Service Alert

ACCESSORY ILLUMINATED DOOR SILL PLATE INSTALLATION INSTRUCTIONS CORRECTION

Service Alert No.: SA-027/22

2023 CX-50

CLIP ORIENTATION

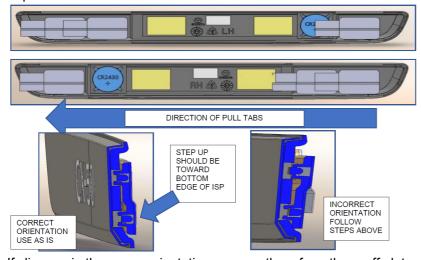
- 1. Remove both left and right front scuff plates from the foam sleeve.
- 2. Turn over and observe the orientation of the attachment clips located on the backside of the parts.
- 3. Clips should be oriented as shown below.

4. If clips are in the wrong orientation, remove them from the scuff plate and reinstall them in the correct orientation.
